Riley Purgatory Bluff Creek Watershed District Permit Application Review

Permit No: 2023-027

Applicant: Daniel Oppedisano
Consultant: Timothy Preston Jr., Stephan Storch, Dynasty Electric Inc.
Project: Demolition of existing single-family home and construction of new single-family home at 7010 Dakota Ave located in Chanhassen, Minnesota.
Location: 7010 Dakota Ave, Chanhassen, MN
Reviewer: Mat Nicklay, Riley Purgatory Bluff Creek Watershed District

CERTIFICATE OF SURVEY FOR DANIEL & PILAR OPPEDISANO

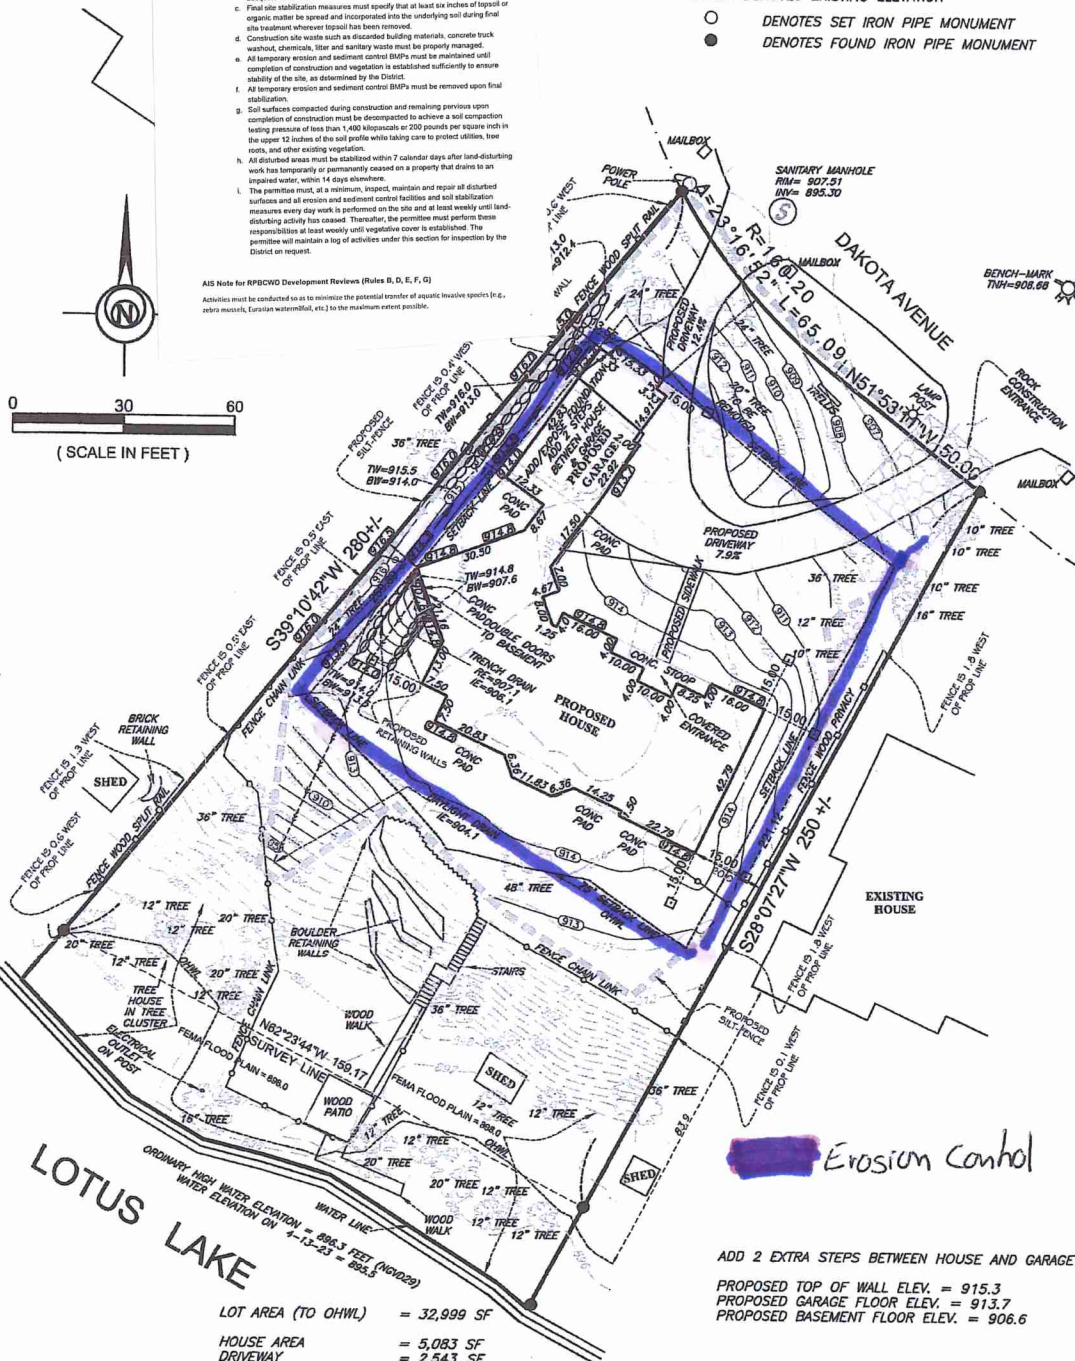
C1. The erosion control plan must include the following notes:

- Natural topography and soil conditions must be protected, including retention of native topsoil to the greatest extent possible.
- Additional measures, such as hydraulic mulching and other practices as specified by the District must be used on slopes of 3:1 (H/V) or steeper to provide adequate stabilization.

- Final site stabilization measures must specify that at least six inches of topsoil or organic matter be spread and incorporated into the underlying soil during final site treatment wherever topsoil has been removed.

- Construction site waste such as discarded building materials, concrete block washout, chemicals, litter and sanitary waste must be properly managed.
- All temporary erosion and sediment control BMPs must be maintained until completion of construction and vegetation is established sufficiently to ensure stability of the site, as determined by the District.

- All temporary erosion and sediment control BMPs must be removed upon final stabilization.
- Soil surfaces compacted during construction and remaining previous upon completion of construction must be decompacted to achieve a soil compaction testing pressure of less than 1,400 Kilopascals or 200 pounds per square inch in the upper 12 inches of the soil profile while taking care to protect adjacent, tree roots, and other existing vegetation.

- All disturbed areas must be stabilized within 7 calendar days after land-disturbing work has temporarily or permanently ceased on a property that drains to an impaired water, within 14 days elsewhere.

- The permittee must, at a minimum, inspect, maintain and repair all disturbed surfaces and all erosion and sediment control facilities and soil stabilization measures every day work is performed on the site and at least weekly until land-disturbing activity has ceased. Thereafter, the permittee must perform these responsibilities at least weekly until vegetative cover is established. The permittee will maintain a log of activities under this section for inspection by the District on request.
